VARIANCE REQUEST			
Iowa Department of Natural Resources			
1. Date:	11/15/12	14. Decision:	Approved
2. Reviewer/Engr.:	Larry Bryant	Date:	11/16/12
3. Date Received:	11/9/12

RE: Phase D Wastewater System Improvements 2011 - Section 1 WPCF Expansion  
City of Fort Dodge  
DNR Project No. S2012-0183  
CWSRF No. CS1920064501

Subject: Variance Request from 567 IAC 64.2(9) and Design Standard 14.4.9.2

Subject: Final Clarifier Flow Split  
City of Fort Dodge Phase D 2011 Wastewater System Improvements

Scenario 4.C, ULR #1 offline & FC#3 offline @ AWW condition, 75% reliability

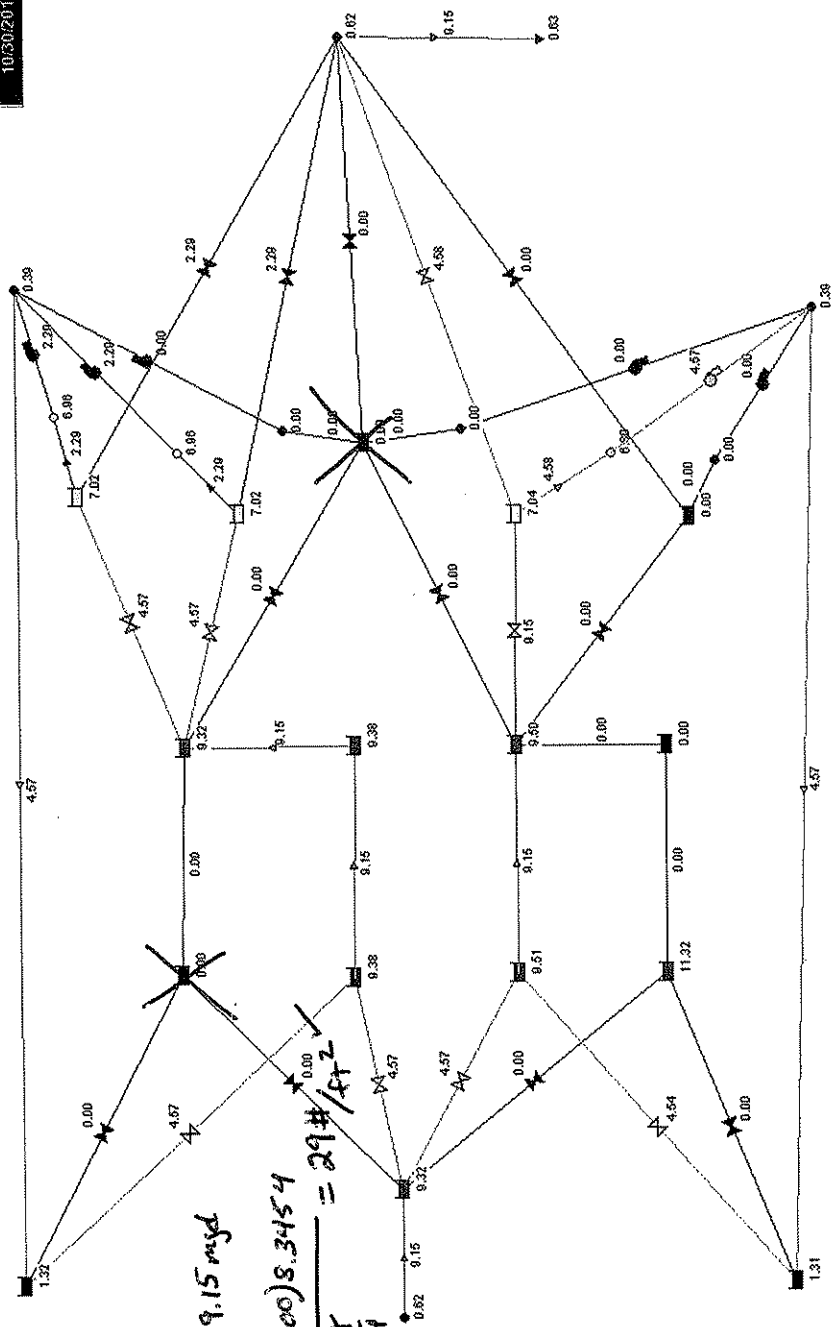
# SWMM Schematic of Splitting Arrangement

## OPTION 5 - ALL FINAL CLARIFIERS ONLINE

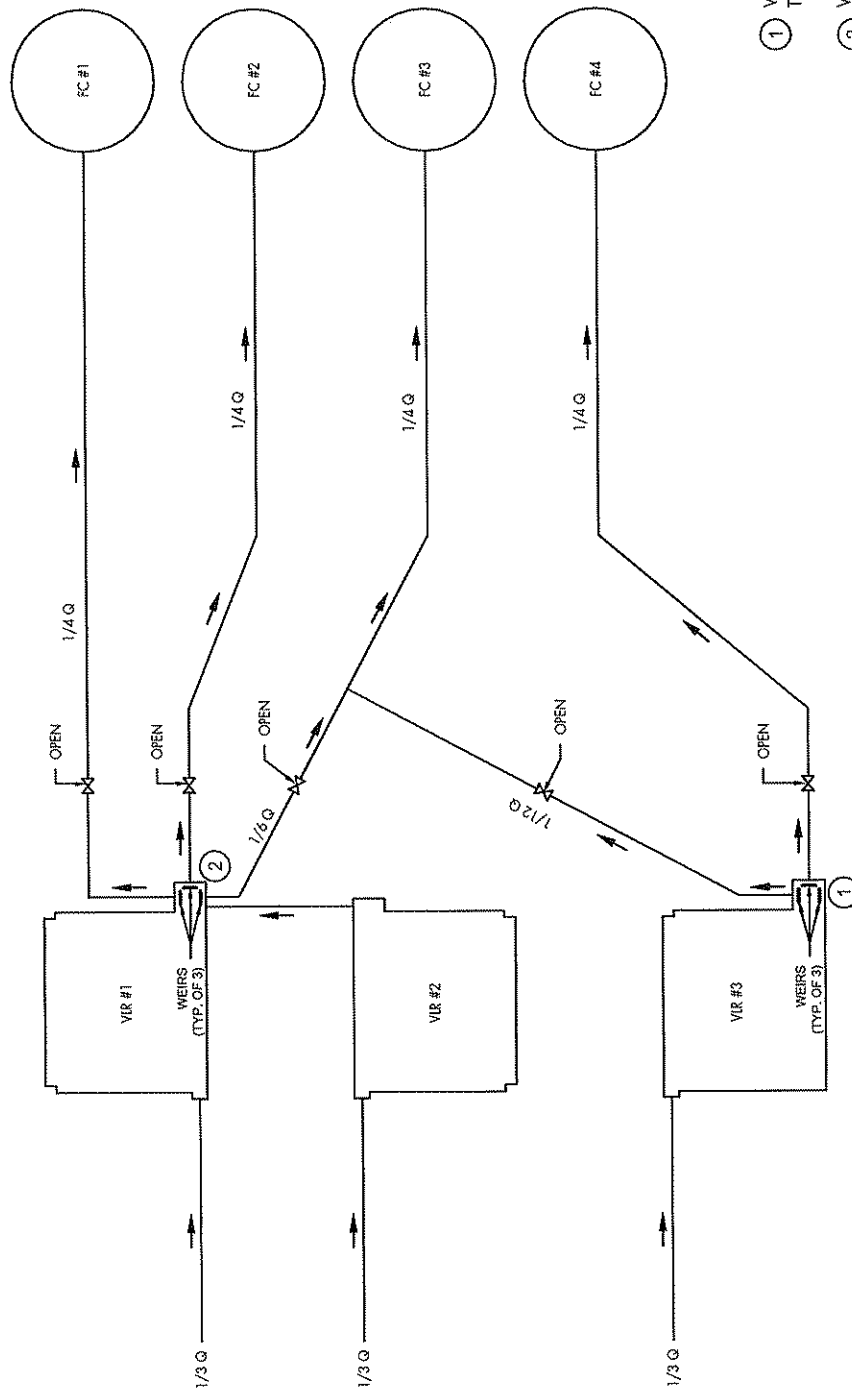
Under the proposed configuration flows among the final clarifiers could not be split evenly with all units online unless two of the five weirs are adjustable in length, which the City/consultant mentions in the petition. Weir heights are typically adjustable but weir lengths are normally fixed. The design details and operational specifics of how the weir lengths would be modified in the field to accommodate an equal 4-way split is not detailed in the variance petition or project plans and specifications. Also, it is not clear from the petition if the City intends to provide whatever equipment would be necessary to accomplish this as part of the project.

Scenario #	Scenario	Even Flow Split w/installed weirs?	Even Flow Split Possible w/Differing Weir Lengths?	Notes	Even Flow Split w/Configuration Meeting Design Standards?
1	3 VLRs online, 4 FCs online	No	Yes. Weir # 3 = 8'. Weir # 4 = 4'.	No details on how the weirs would be adjusted	Yes
2.a – d	3 VLRs online, 3 FCs online	Yes	N/A	For any one of the 4 FCs taken offline.	Yes
3.a	VLR # 1 offline, 4 FCs online	Yes	N/A	Close Valve # 3.	Yes
3.b	VLR # 2 offline, 4 FCs online	Yes	N/A	Close Valve # 3.	Yes

- ① WEIR ADJUSTED TO  $1/3$  NORMAL WIDTH TO PROVIDE DESIRED FLOW SPLIT
- ② WEIR ADJUSTED TO  $2/3$  NORMAL WIDTH TO PROVIDE DESIRED FLOW SPLIT
